Toye Simmons  
U. S. Nuclear Regulatory Commission  
Materials Licensing Section  
2443 Warrenville Road, Suite 210  
Lisle, IL 60532-4352

**RE: Control Number 319041**

Please allow this letter to serve as a response to questions you had concerning a request to amend the Materials License of C & G Technologies, number 13-32739-01. Information will be provided in the order it was requested in your letter dated May 21, 2010.

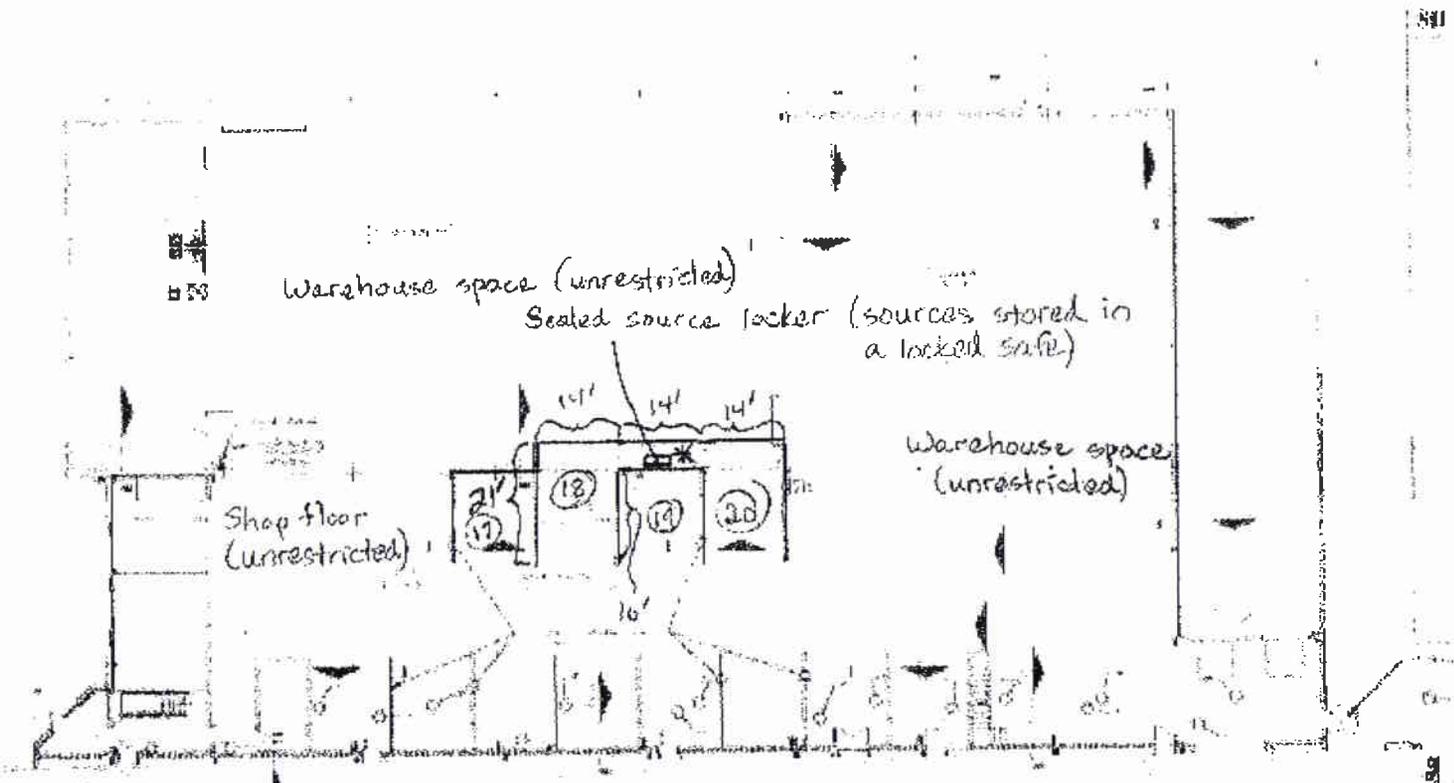
4. Enclosed is a diagram showing the areas where the F-18 will be used and stored. Please note that there is not a significant change in the unrestricted and restricted areas.

⑱, ⑲, ⑳ are room numbers

⑱ and ⑳ are areas used for refurbishing PET scanners

⑲ is an area used for refurbishing CT scanners as is ⑰

F-18 will be stored in the area marked \* and will be used in rooms ⑱ and ⑳
